ELECTRONICS FIELD CHANGE BULLETIN	AN/FRT-39
BUREAU OF SHIPS, NAVY DEPARTMENT	AN/FRT-40
WASHINGTON, D. C.	AN/FRT-62

**PURPOSE:** This modification provides remote on/off control of the transmitter carrier. In addition, the unit provides an indication of transmitter status by means of signals to a display board located at the transmitter monitor control console or elsewhere at the transmitter site. In order to accomplish this modification, Tone Intelligence Unit Model TIS-3 is physically replaced by Transmitter Keyer Monitor Control Unit, Model KMCU-1. Tone Intelligence Unit TIS-3 will be relocated to the CCL facilities at the transmitter site or to some other remote location.

TEMPORARY CORRECTION TO TECHNICAL MANUAL FOR RADIO  
TRANSMITTING SETS AN/FRT-39, AN/FRT-40, and  
AN/FRT-62

INTERCONNECT WIRING DIAGRAM,  
MODIFICATION FOR KMCU  
INSTALLATION  
FIGURE 4

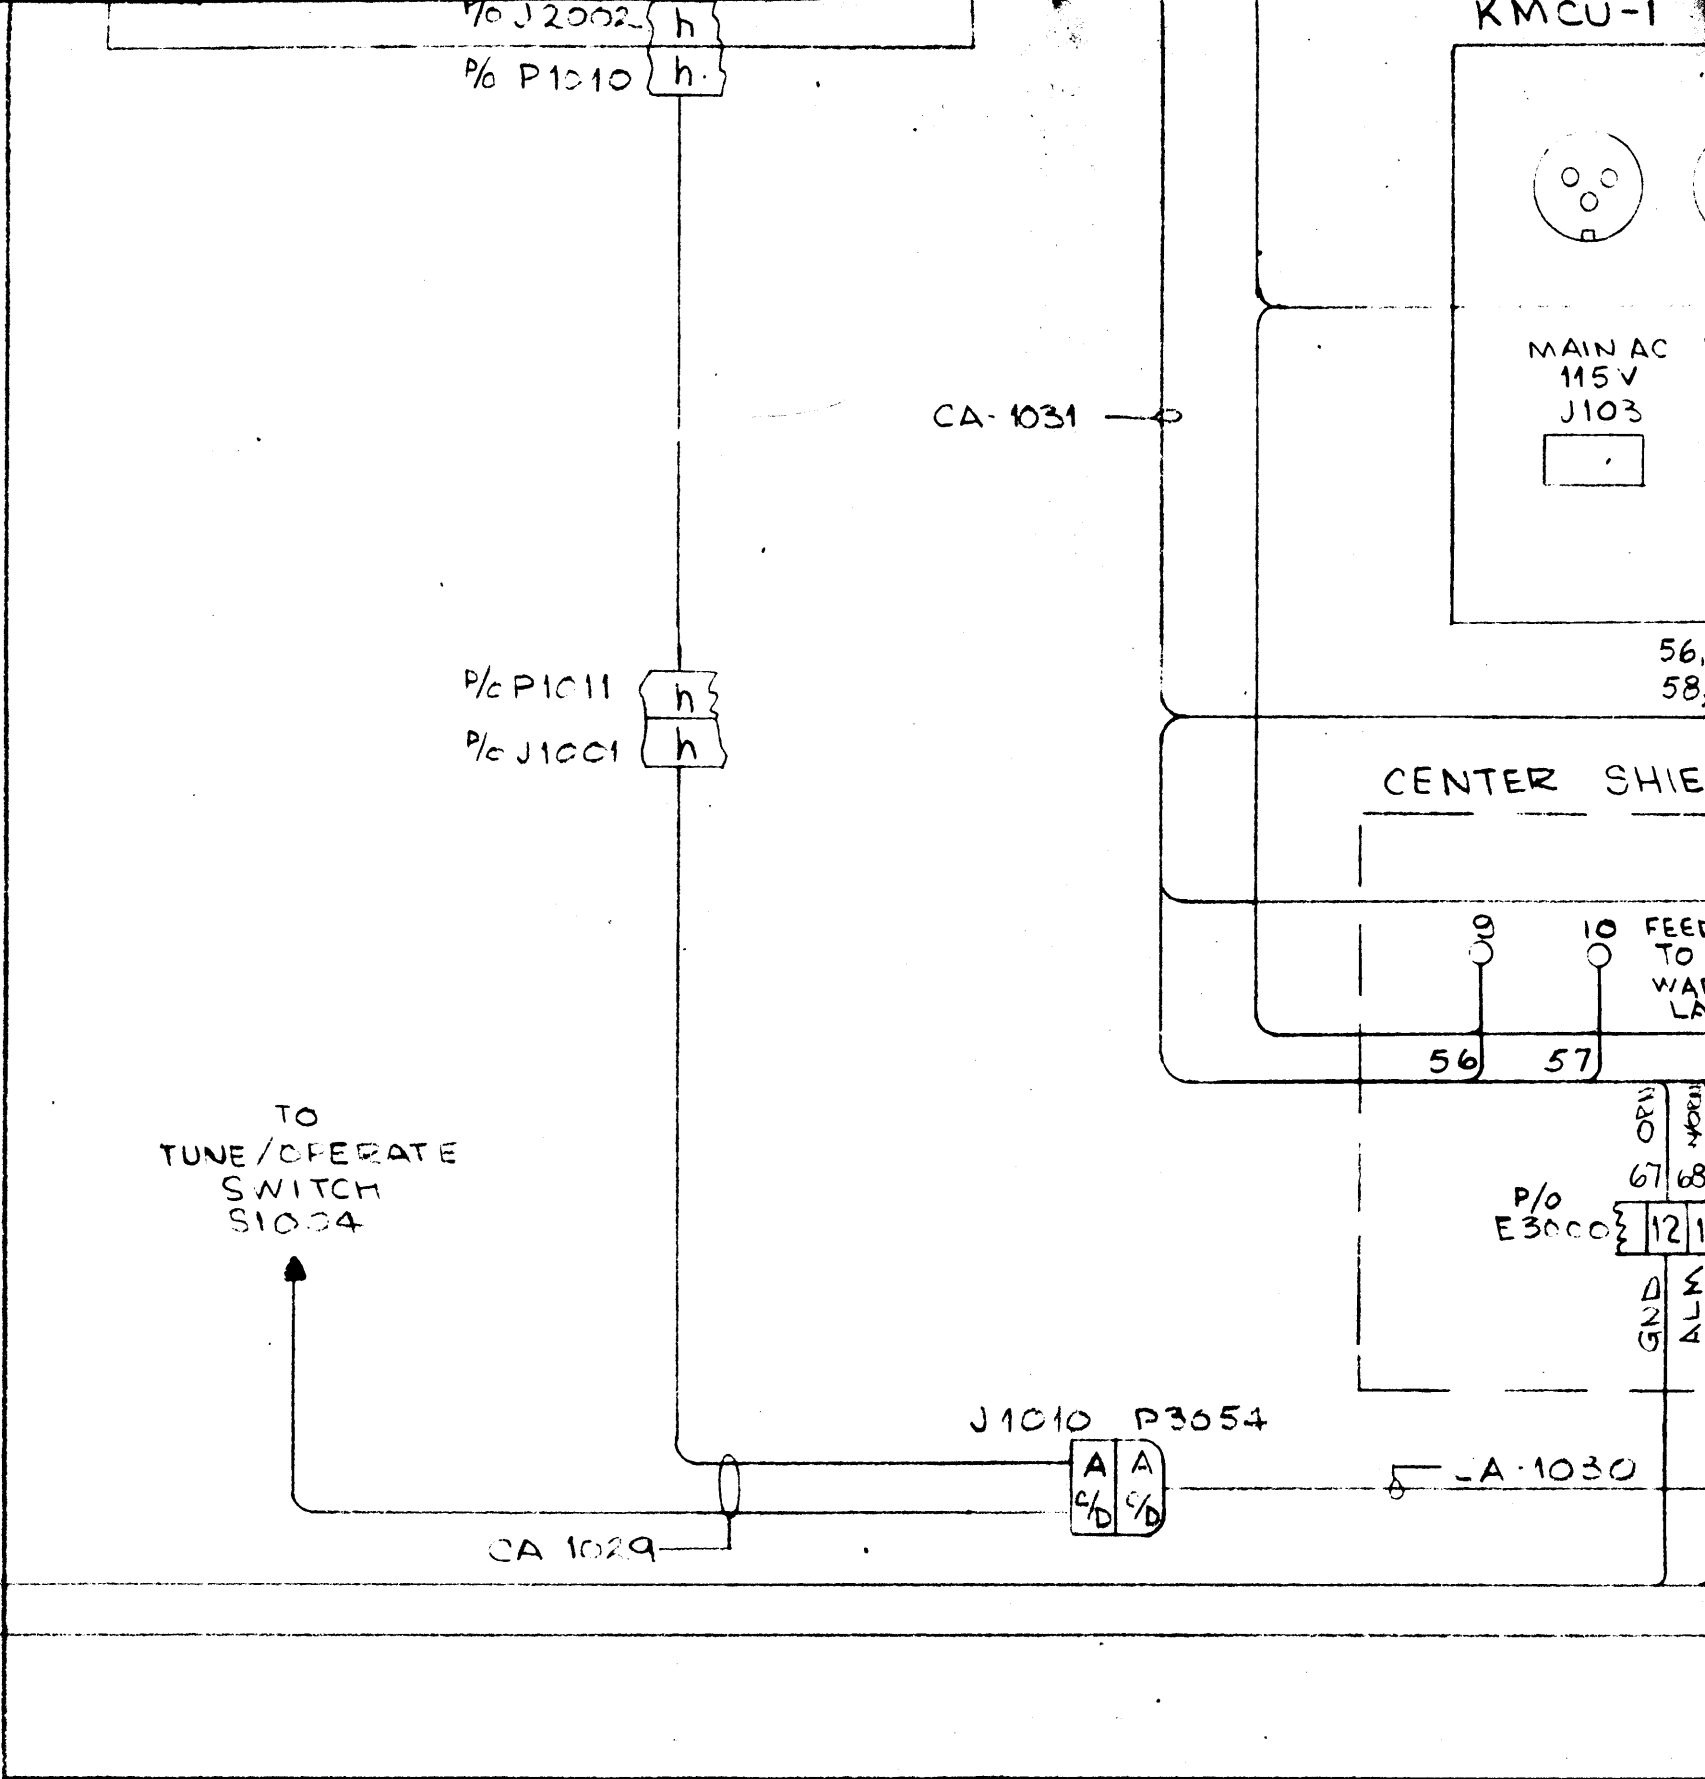
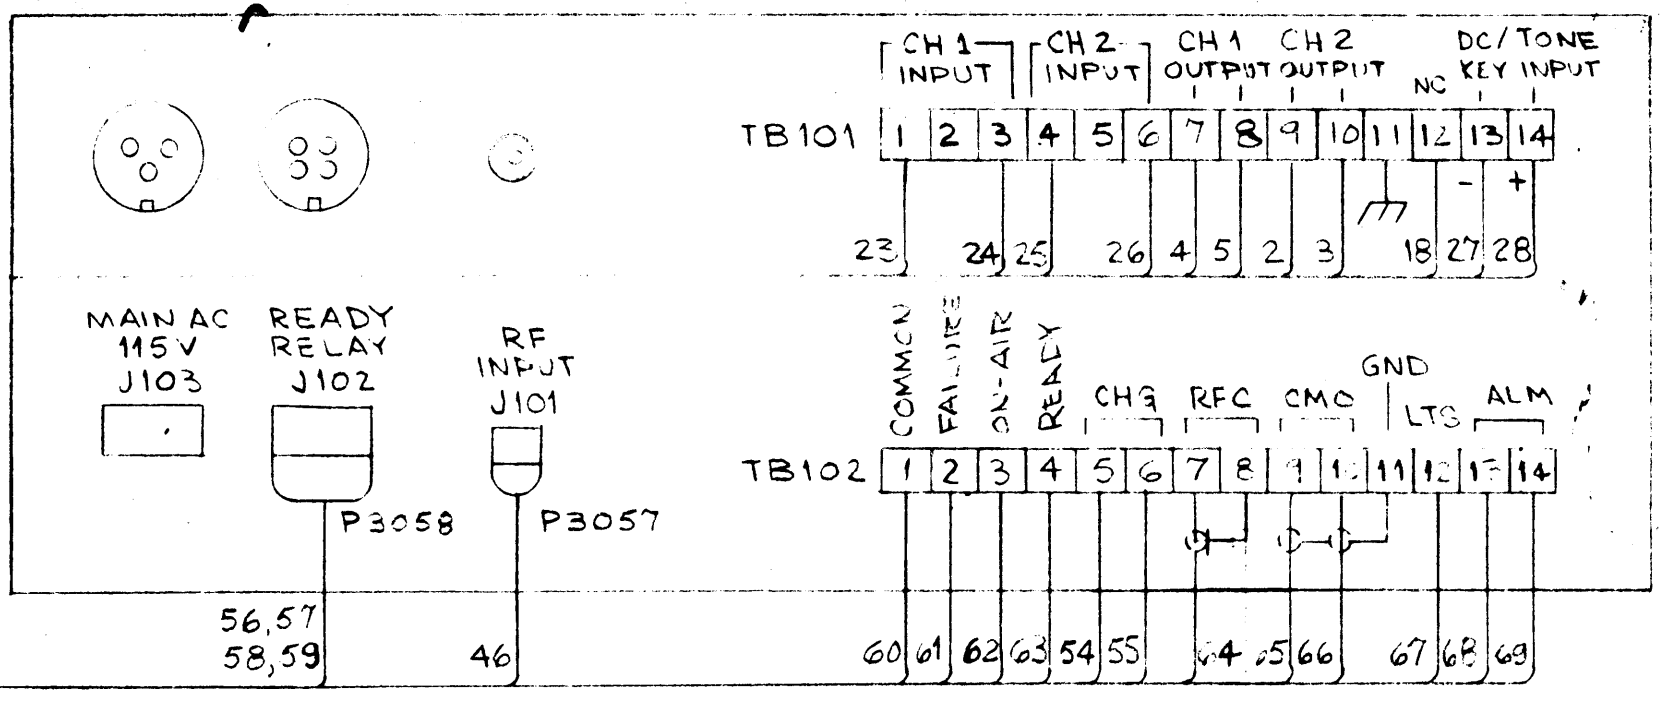
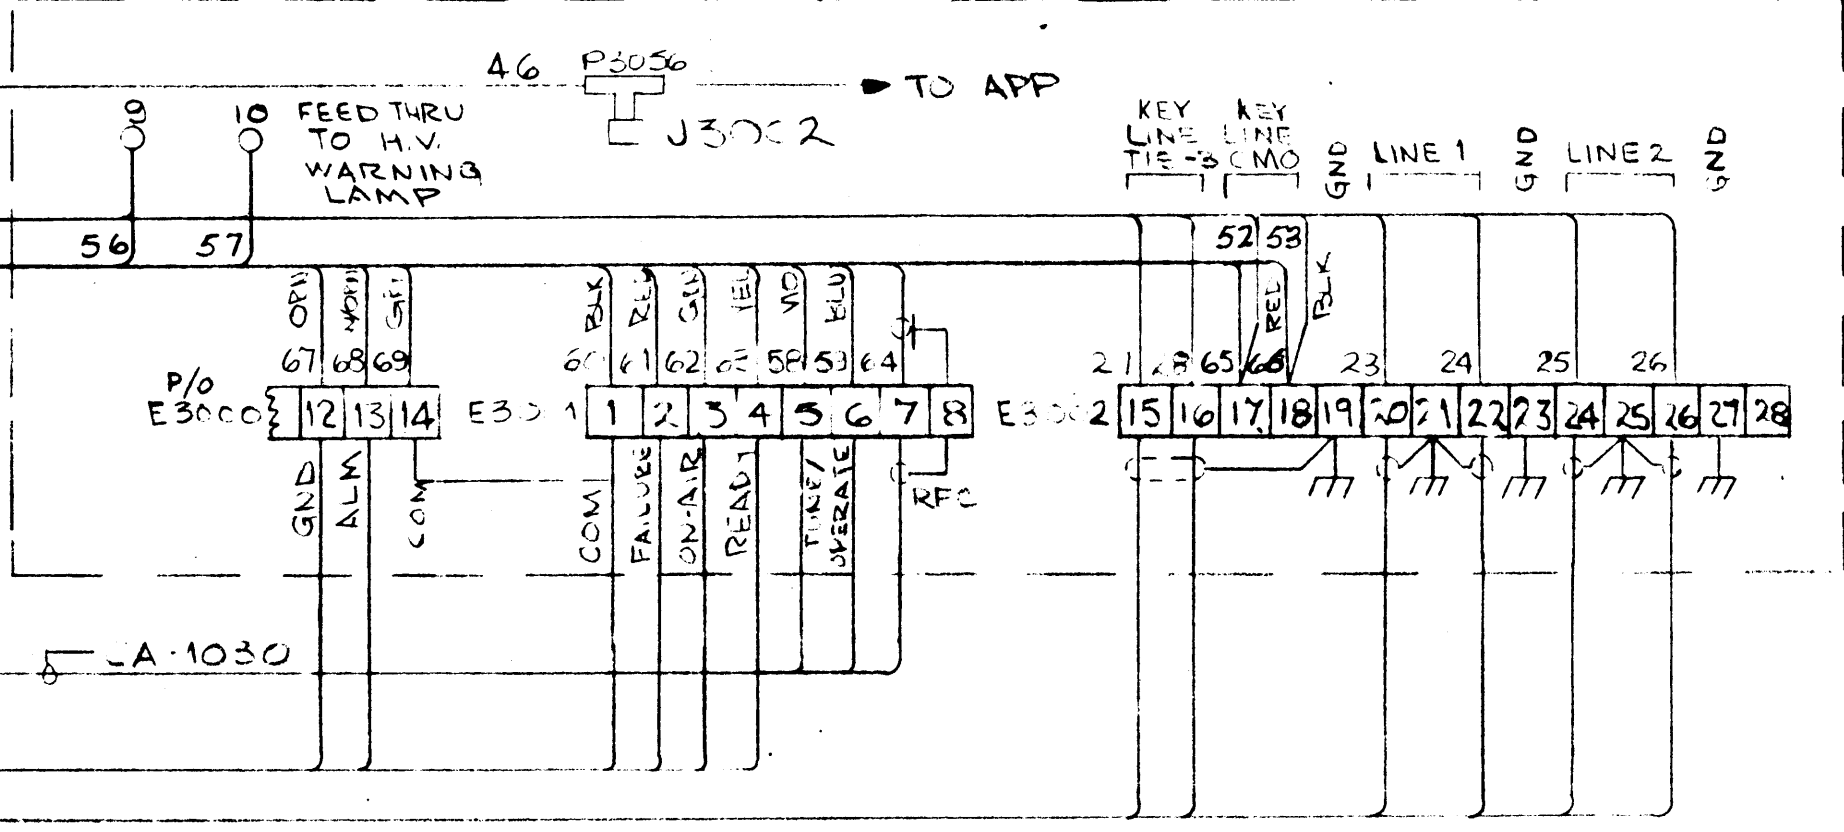
3. VOLUME 1S (Sideband Generator, Model SBG-1/2). - Wiring interconnection diagrams given in Section 2 should be changed in accordance with information contained in figure 4.
